From: [REDACTED]
To: [REDACTED]
Sent: 2/24/2021 1:01:14 PM
Subject: FW: O8W-PM 35217268, 35224712, 35224713 - Bucks Creek 1101 Phase 1,2&3 - Pre-Engineering Meeting

Subject: O8W-PM 35217268, 35224712, 35224713 - Bucks Creek 1101 Phase 1,2&3 - Pre-Engineering Meeting

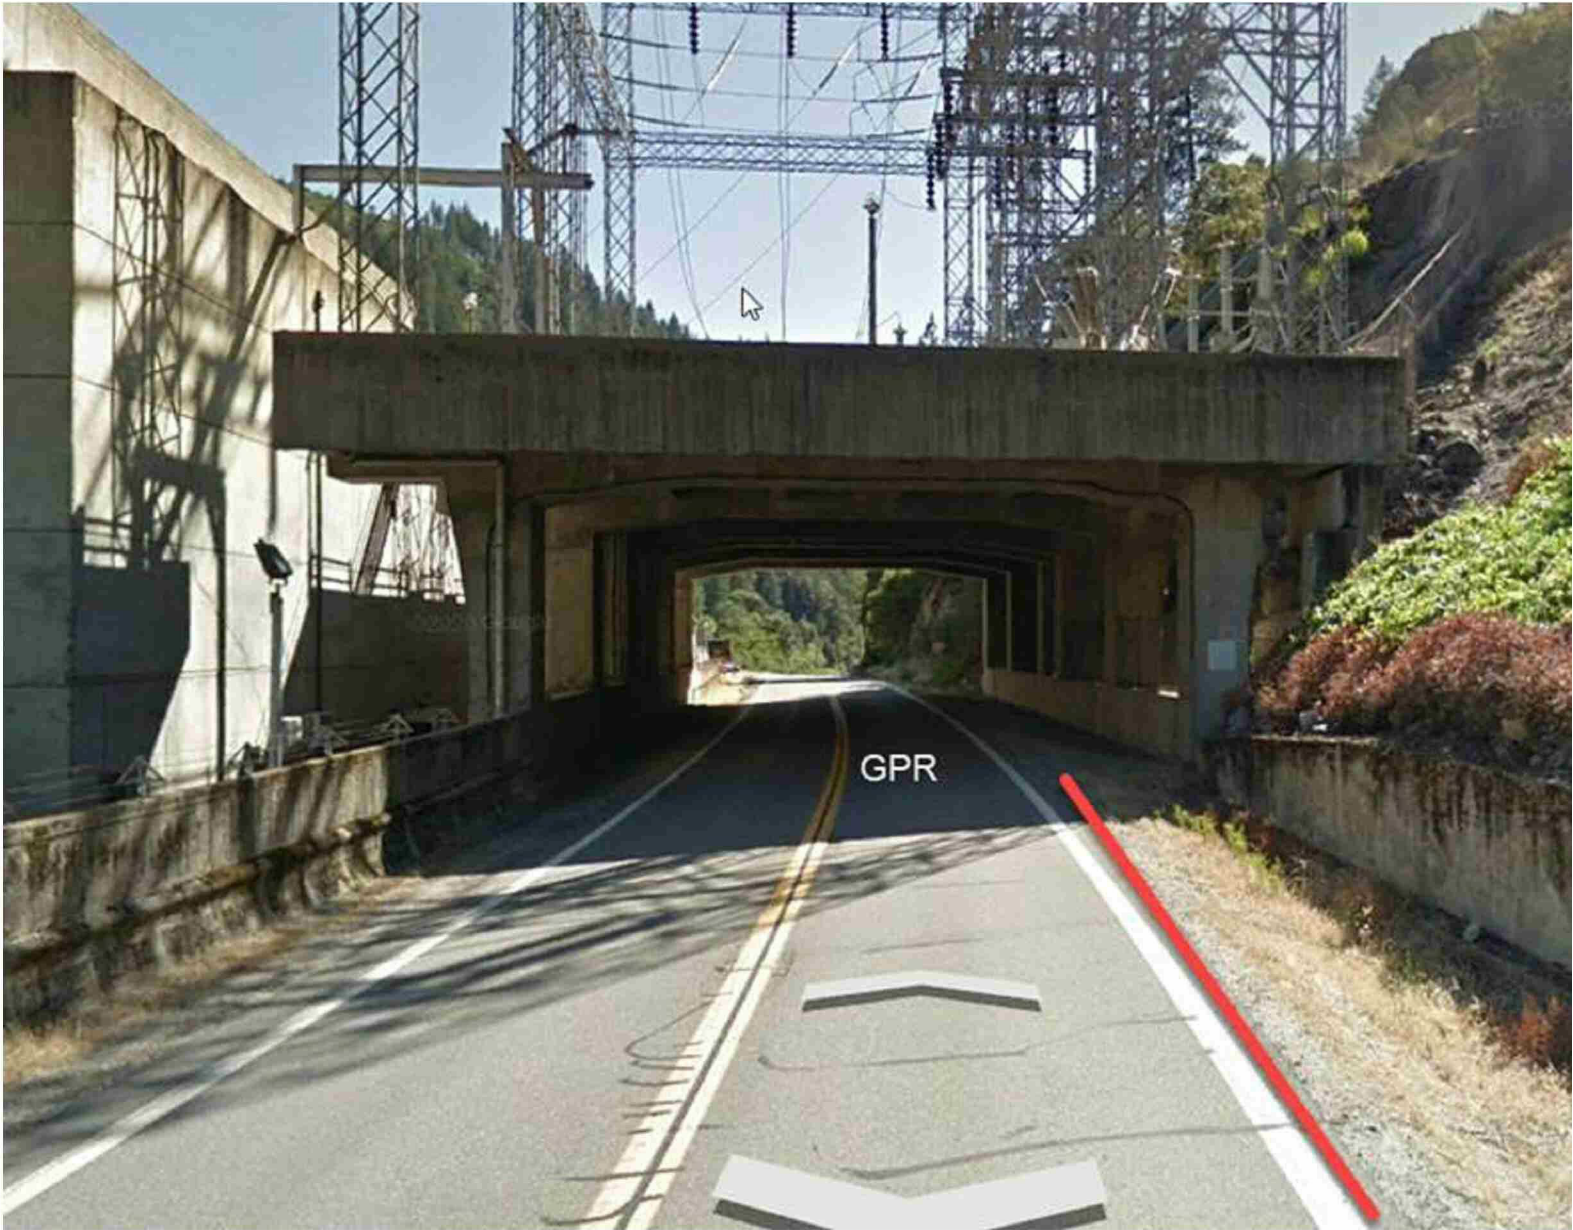
Your outlet red-line Bucks Creek looks close to what I was thinking. Need to work with [REDACTED] to get this designed with a single 6" and use #5 boxes with 200A cable. There is not a reason this will need (2) 6" and 1-4" and 7 boxes. There is probably only 20a peak on the primary now.

Rock Creek

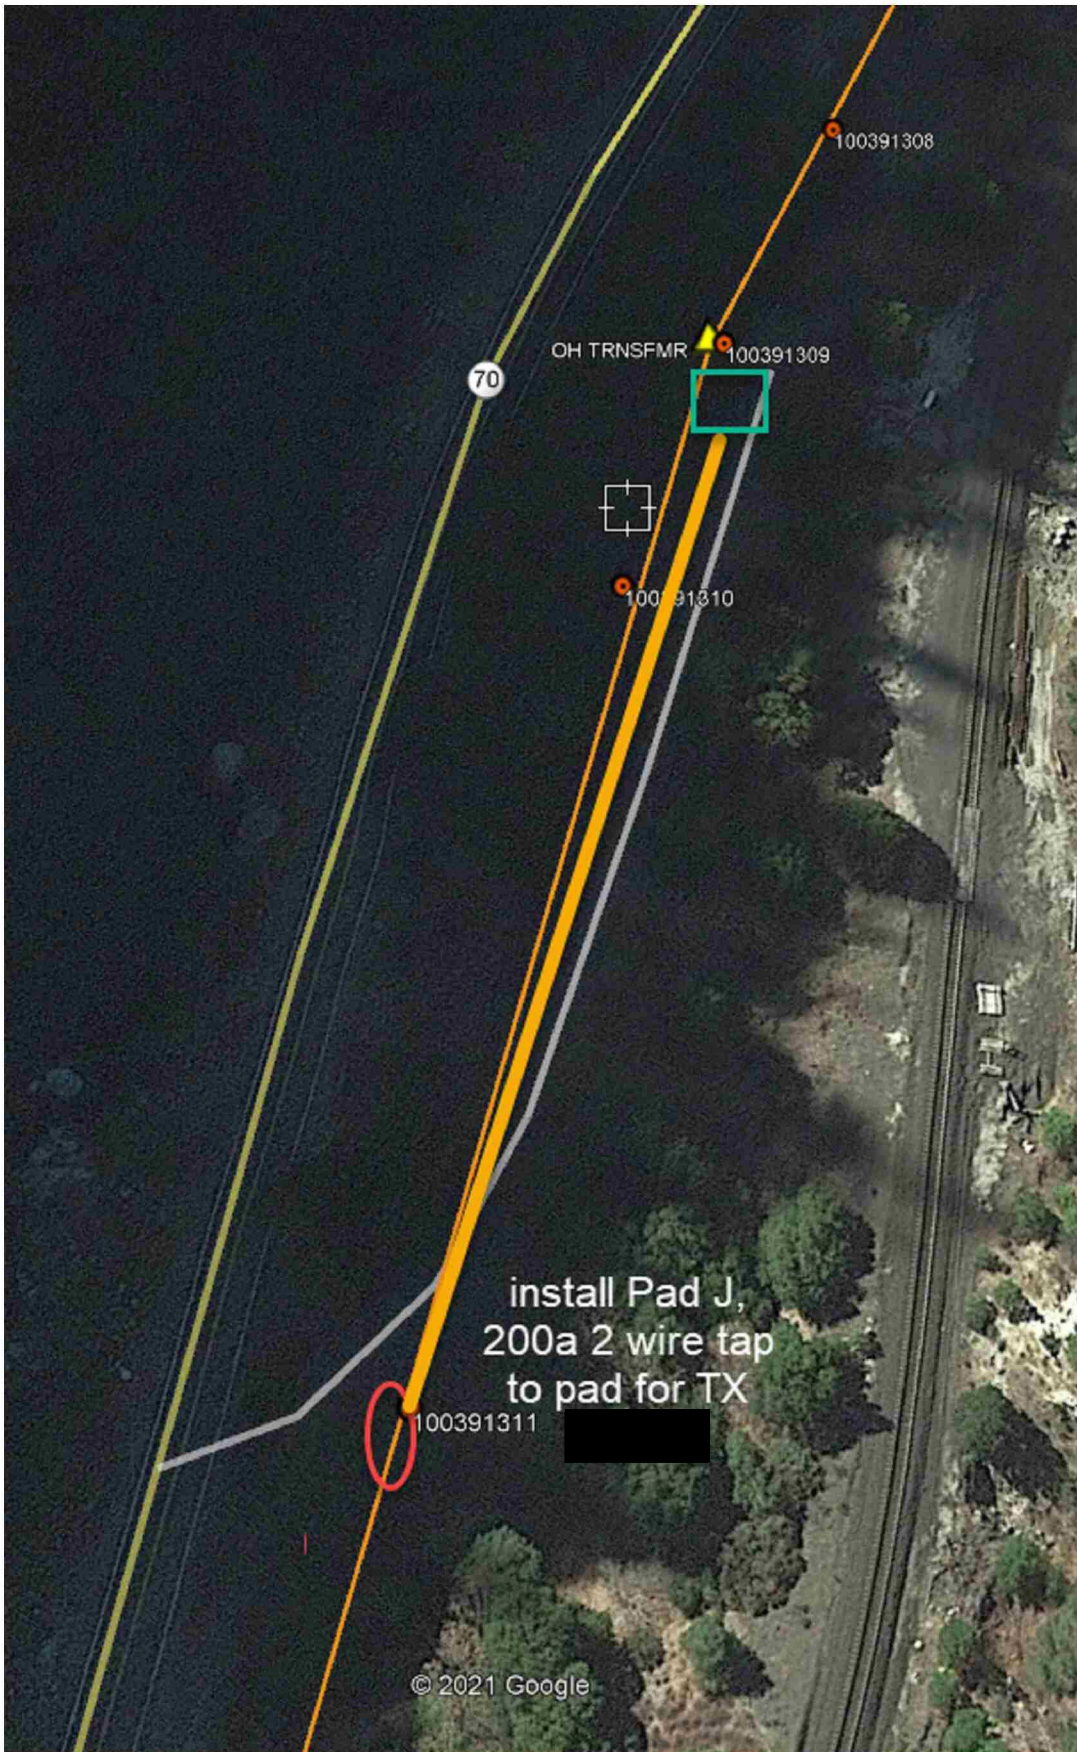
Merlin can go back like we just did Poe. Pad on the Highway and tension secondary 1/0 ASCR across the river. We can negotiate to move the service point with my MSA electrician.

we can serve Merlin with either circle, OH 1/0 ASCR triplex tension across the river.
